# UNITED STATES PATENT AND TRADEMARK OFFICE

10/502,500

<b>Office Action Summary</b>	<b>Application No.</b> 10/502,500	<b>Applicant(s)</b> BOGDAHN ET AL.	
	<b>Examiner</b> JASON L. LAZORCIK	<b>Art Unit</b> 1791

### **DETAILED ACTION**

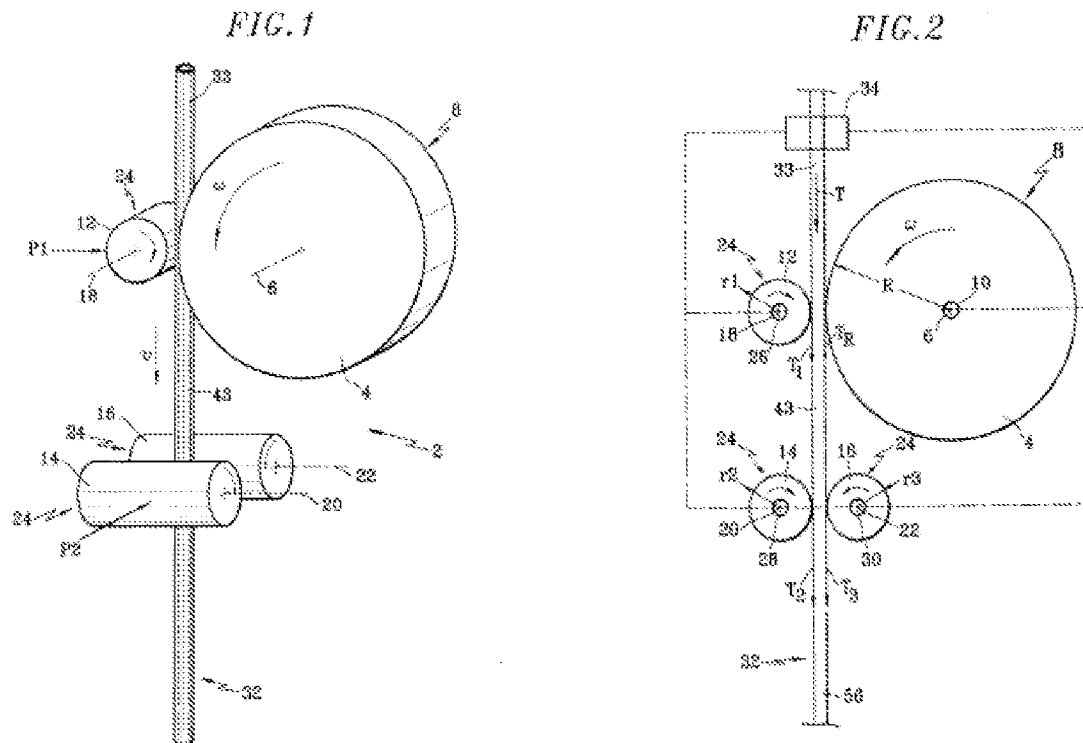
The method comprises first supplying said ingot to the heating zone of a furnace to heat soften the glass preform (Pg /6, lines 17-34). With particular reference to the following excerpt figure 2, Boscher discloses a “draw-off device” (2) for use in a vertical drawing method whereby a glass strand is drawn from the heat softened glass at a “controlled drawing speed”. The draw-off device (2) comprises a “first draw-off unit” (4, 12) including a “reference rolling body” (4) and “at least one auxiliary rolling body” (12) distributed about the circumference of the drawn glass strand (33).

The draw-off device (2) further comprises “at least one additional draw-off unit” (14, 16) including a plurality of rolling bodies (Claim 3). The plurality of rolling bodies (14, 16) are adapted to provide an adjustable contact pressure with a “means of pressure” (Pg /7, lines 20-29, and Pg /10, lines 5-19) or “a damper” (**Claim 9**) which is understood to be “movable in a direction perpendicular to the long axis of the glass strand” (**Claim 4, 6**).
